BRANEX-COG FEDERAL COM 27H

9. API Well No.  
30-025-4100610. Field and Pool, or Exploratory  
MALJAMAR YESO WEST

COG Operating LLC respectfully requests permission to change the BHL of this well as follows:

**Branex - COG Federal Com - 27H - API 30-02541006: EC291194 Sundry Notification**

Project: LEA COUNTY, NM  
 Site: MALJAMAR  
 Well: BRANEX-COG FEDERAL COM #27H  
 Wellbore: OWB  
 Design: PWPO

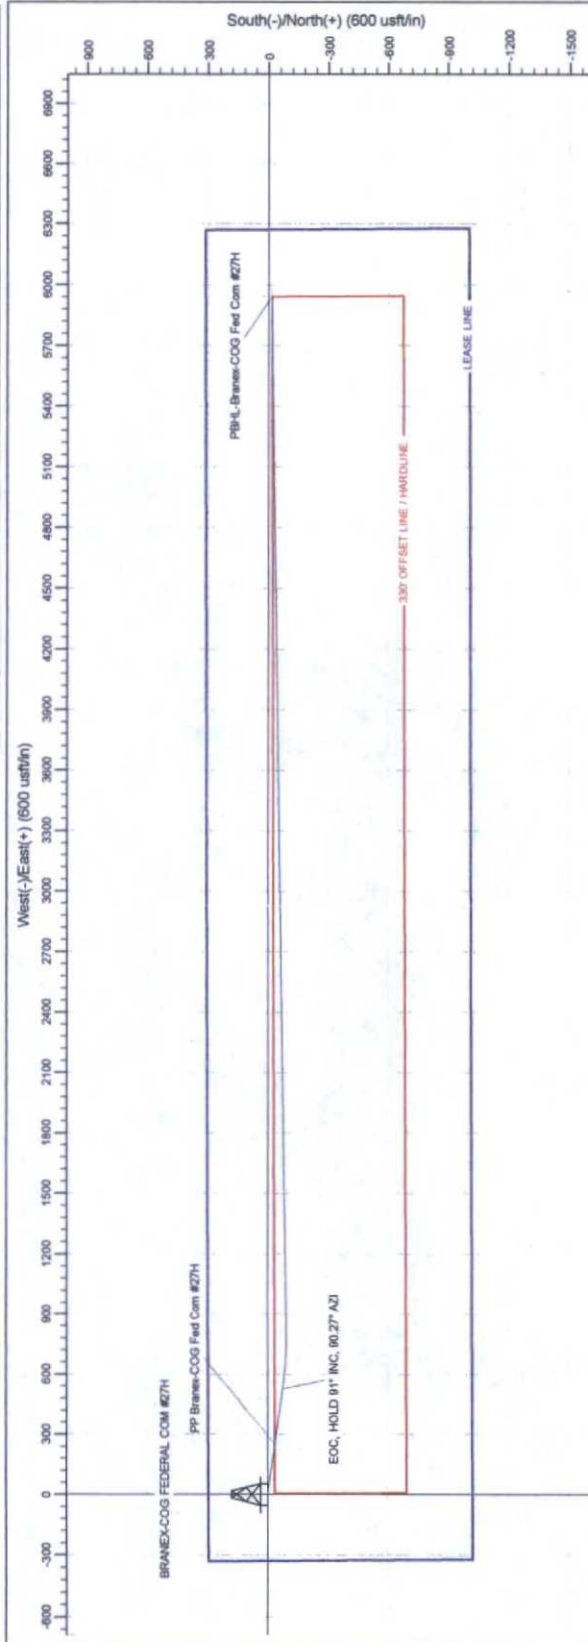
FROM:  
SHL 1025 FSL & 330 FWL Sec 9, T17S, R32E, UL M  
BHL 990 FSL & 330 FEL Sec 9, T17S, R32E, UL PTO:  
SHL 1025 FSL & 330 FWL Sec 9, T17S, R32E, UL M  
BHL 990 FSL & 990 FWL Sec 10, T17S, R32E, UL M**SEE ATTACHED FOR  
CONDITIONS OF APPROVAL**

This sundry was necessary because another ¼" mile was added to EOL.
